Ship/HULL NO.	Ship/HULL NAME	JON:	ICN:	Rev:	Key Op:
LCU-1651	NBU-7		38NBA51213		A01

Ventilation Duct in Galley and Weather Deck; replace

JOB SPECIFICATION

Terashita-san,
This serves as S245 response to LCU51-0115.

ENCLOSURE (A) 1 / 1

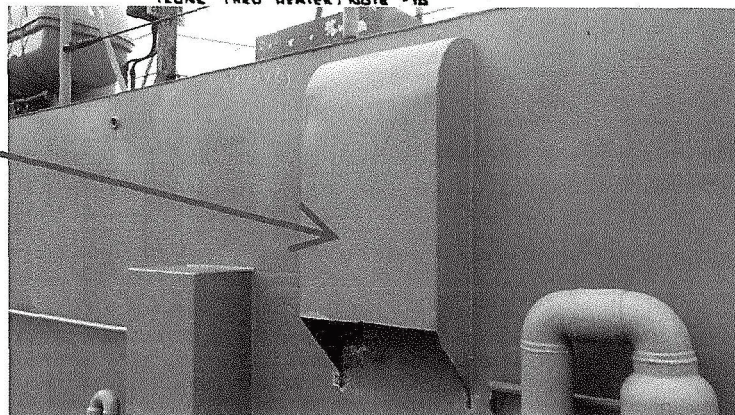
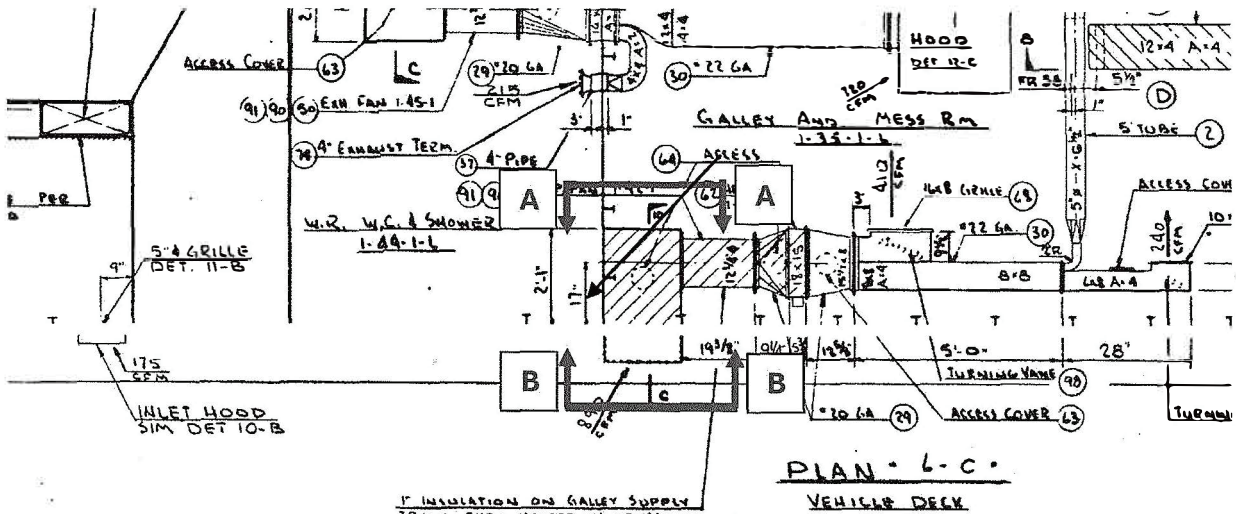
1. Ship's Force requests to replace vent duct opening assembly including water tight cover and louver at Galley and Mess Room (1-44-1-L).
2. As-built drawing Ref.(C) does not match with current condition.
3. There is no record of such modifications having been made in the past.
4. As a result, due to the lack of information regarding the duct opening assembly, it has become difficult to proceed with material ordering and the preparation of the TGI.

1. Use Ref.(B) / Encl-(1) and (C) for the replacement vent duct including water tight cover.
2. The vanes (louvers) do not require due to natural ventilation system.
3. Damage Control Closure Label Plate Circle W to be installed as current condition.
4. No drawing can be found locally that matches current condition as removal the supply fan system and duct from Ref. (C).
5. Ref.(B) is available in Yokosuka DDRS (Design Data Research System).

DOCUMENT	SCALE	SHEET
501 DLM-052016	NONE	5 OF 5

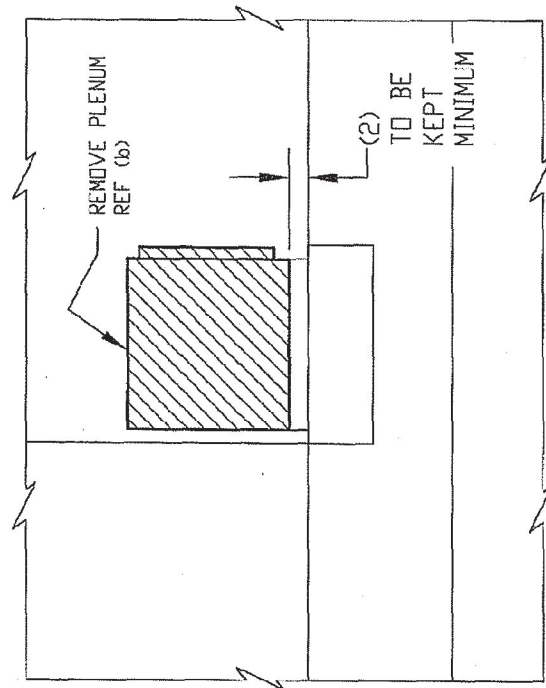
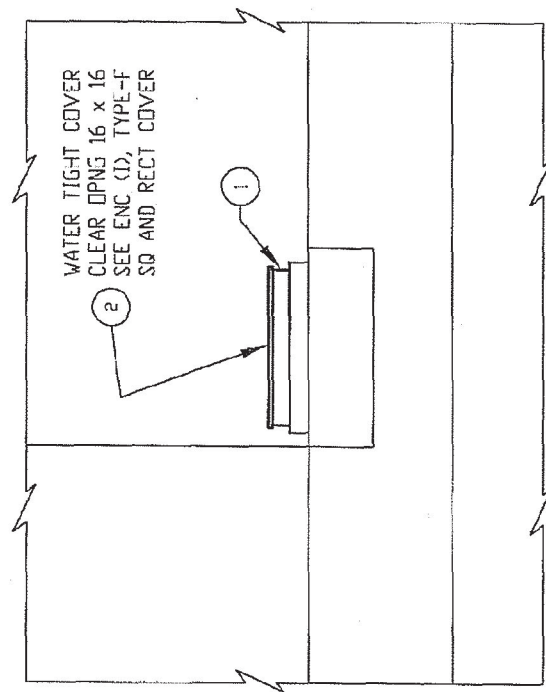
ACTION: Remove the existing dead vent plenum and install a water tight cover IAW sheets 4 & 5 and ENCLOSURE (I).
